Access Compliance Report

Public Rights-of-Way

Intersection ID: 12182	Main Street: BRYANT_ST	Cross Street: S_SUMMIT_AV	Location: SE
ADA ID: 0EFB6A75A388	Ramp Type: BlendTrans1	Initial Pass/Fail: Fail	Overall Compliance: No
		Severity Score: 10

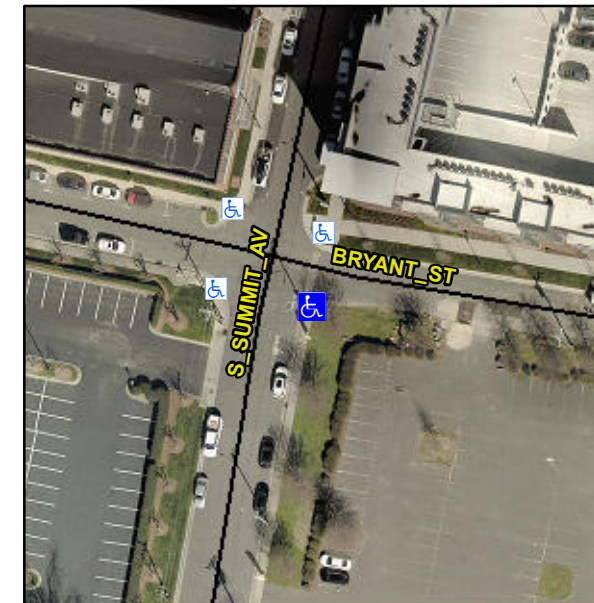
DIST. FROM UTIL. POLE TO BACK OF SW = 60"

R304.5.1, R304.5.3

Compliance	Description	Data	Compliance	Description	Data
N/A	Ramp Length (in)	56.0	Yes	BlendTrans Slope (%)	4.3
No	Ramp Width (in)	39.0	No	BlendTrans XSlope (%)	4.0
N/A	Flare Type LT	N/A	N/A	Flare Type RT	N/A
N/A	Flare Slope LT (%)	N/A	N/A	Flare Slope RT (%)	N/A
N/A	Flare Traversable LT?	N/A	N/A	Flare Traversable RT?	N/A
N/A	Landing Length (in)	N/A	N/A	DWS Provided?	N/A
N/A	Landing Width (in)	N/A	N/A	DWS Contrast?	N/A
N/A	Landing Slope (%)	N/A	N/A	DWS Length (in)	N/A
N/A	Landing X Slope (%)	N/A	N/A	DWS Full Width?	N/A
N/A	Landing Curb? (Y/N)	N/A	N/A	DWS Offset (in)	N/A
N/A	Shared Landing?	N/A			
N/A	Gutter Ponding?	N/A	N/A	Gutter Slope (%)	N/A
N/A	Gutter Lip Ht (in)	N/A	N/A	Gutter X Slope (%)	N/A
N/A	Painted X Walk1?	No	N/A	Painted X Walk2?	No
	X Walk 1 Direction	To N		X Walk 2 Direction	To W
	X Walk 1 Width (in)	N/A		X Walk 2 Width (in)	N/A
	X Walk 1 Slope (%)	4.5		X Walk 2 Slope (%)	1.9
	X Walk 1 X Slope (%)	1.7		X Walk 2 X Slope (%)	1.4

Remove & Replace Curb Ramp With Two New Directional Ramps or Equivalent.
